CITY OF CARSON

PLANNING COMMISSION STAFF REPORT

PUBLIC HEARING:	July 12, 2011			
SUBJECT:	Conditional Use Permit No. 796-10			
APPLICANT/PROPERTY OWNER:	Amalia Torres 2708 East Adams Street Carson, CA 90810			
REQUEST:	To approve a Conditional Use Permit for a second dwelling unit located within the RS (Residential Single-Family) zoning district.			
PROPERTY INVOLVED:	2708 – 2710 East Adams Street			
COMMISSION ACTION				
Concurred with staff				
Did not concur with staff				
Other

Building Inspection Report

Figure 1-switch inside enclosure

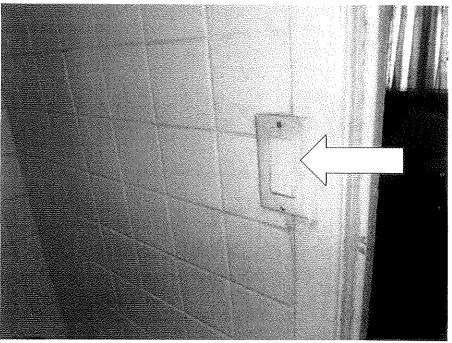
- 5. Safety Issue: A light switch was observed in close proximity to the tub/shower on the upper level (see figure 1). Suggest modification or relocation of electrical for safety reasons.

Figure 2-running splices new to old wiring

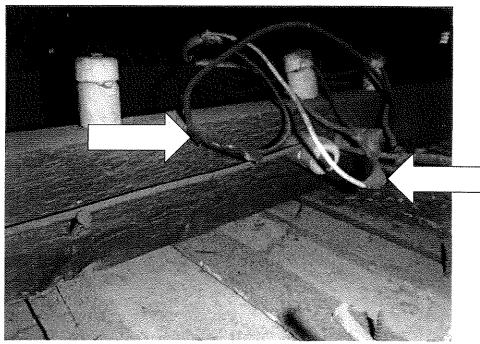
- 6. Safety Issue: Running splices and or open junction boxes noted at the attic space and garage (see figures 2 5); running splices noted at the attic space (older knob and tube wiring was observed in the attic to be connected to new wiring; such connections are often suspect); all electrical connections should be made within covered junction boxes; suggest conforming installation.

Figure 6-exposed Romex wiring and missing outlet and switch wall plates

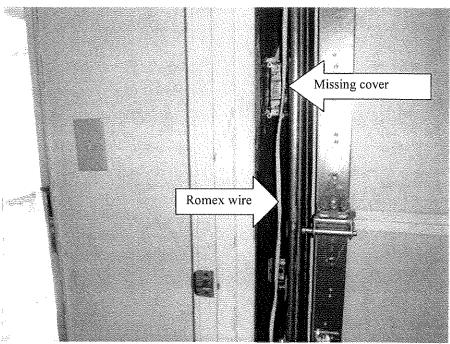
- 7. **Safety Issue:** Exposed romex/improper wiring noted in the garage (improper usage of material see figures 6 as an example). All visible wiring should be enclosed within flexible or rigid metal conduit; suggest conforming installation.

Figure 7-water heater is not strapped; no Temperature and Pressure Relief (TPR) Valve discharge pipe

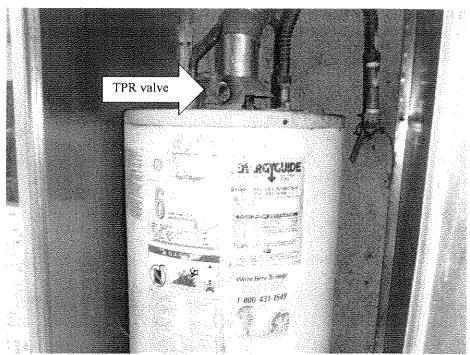
- 8. Safety Issue: The water heater is not strapped (see figure 7). Water heaters in seismic zones should be properly double strapped snug to the wall with approved straps at the top and bottom third of the unit (the upper strap should not be no closer than 9" from the top and the lower strap should be no lower than 4 inches above the gas connection) to resist any horizontal movement during earthquake conditions; suggest conforming installation. Note: The straps should not cover the water heater manufacture's date plate.

- 9. Safety Issue: Water heater Temperature and Pressure Relief (TPR) valve rigid discharge pipe should be installed (see figure 7). This rigid metal pipe should ideally be routed to the exterior and extend no closer than 6" and no further than 24" above the ground and pointing downward. Such drains may terminate at other approved locations. The lack of such a valve/pipe assembly is a safety concern. Suggest conforming installation.

Figure 9-wood deterioration below upper level bathroom

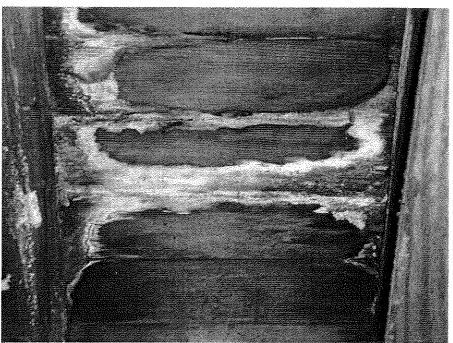
- 1. **Improve:** Wood deterioration noted at the sub floor located under the tub (see figure 9); suggest repair and referring to the pest control report.
- 2. **Improve:** Concrete/wood curb noted at the base of the garage overhead door; suggest removal. Also, the structure above the roll up door should have a single sized structural beam to support the load above.

Figure 10-one the many damaged/missing attic ventilation screens

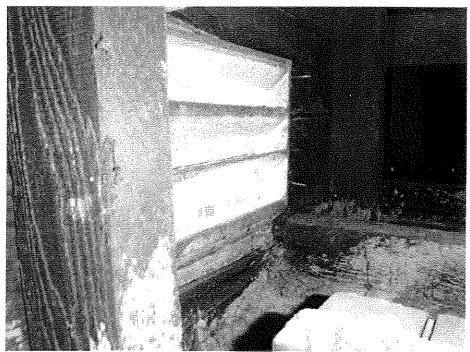
- 5. Improve: There is no heating source for the lower level living space.
- 6. **Improve:** Various attic ventilation screens are been obstructed/damaged/missing (see figure 10 as an example). Suggest repairs as needed.

Figure 11-gas line embedded in concrete

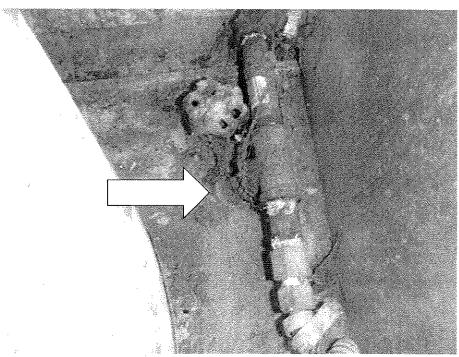
- 7. **Improve:** Gas supply pipe at the water heater is embedded in concrete without the benefit of pipe wrap (see figure 11). This tape will prevent corrosion of the pipe and allow it some movement during seismic activity.

Figure 12-waer heater vent does not discharge pass roof

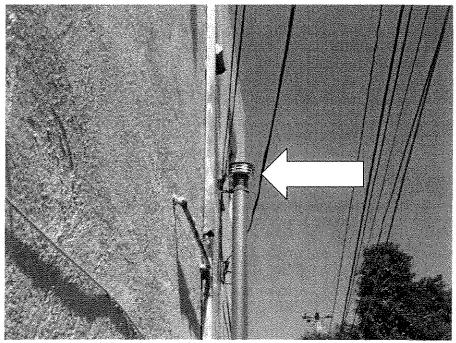
- 8. **Improve/Safety Issue:** The vent pipe serving the water heater is of insufficient height and requires improvement. The pipe should be extended 2 feet above the adjacent roofline (see figure 12); suggest further review by a licensed plumbing contractor prior to the close of escrow or contingency period.

Figure 13-uneven height of the first riser with the other risers

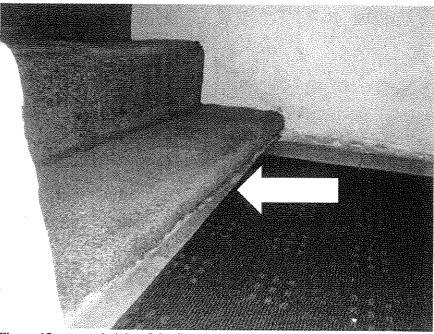
- 12. Improve: The kitchen exhaust hood light and fan are inoperative.
- 13. **Improve:** The size and/or orientation of the stairway first riser may make the stairway difficult to negotiate (see figure 13). Ideally, this condition should be altered for improved safety.

Figure 14-wood boring insect activity in the attic at the SW corner

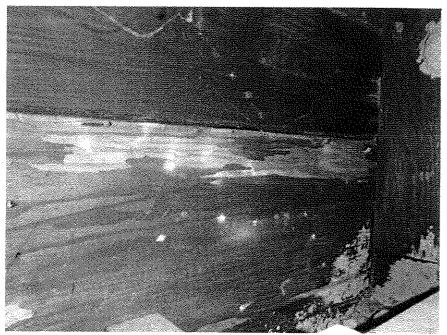
- 2. **Monitor:** Evidence of wood boring insect activity was observed in the attic at the SW corner of the exterior wall (see figure 14). A licensed pest control specialist should be engaged to evaluate this condition and recommend measures to eliminate further wood boring insect activity within the home.
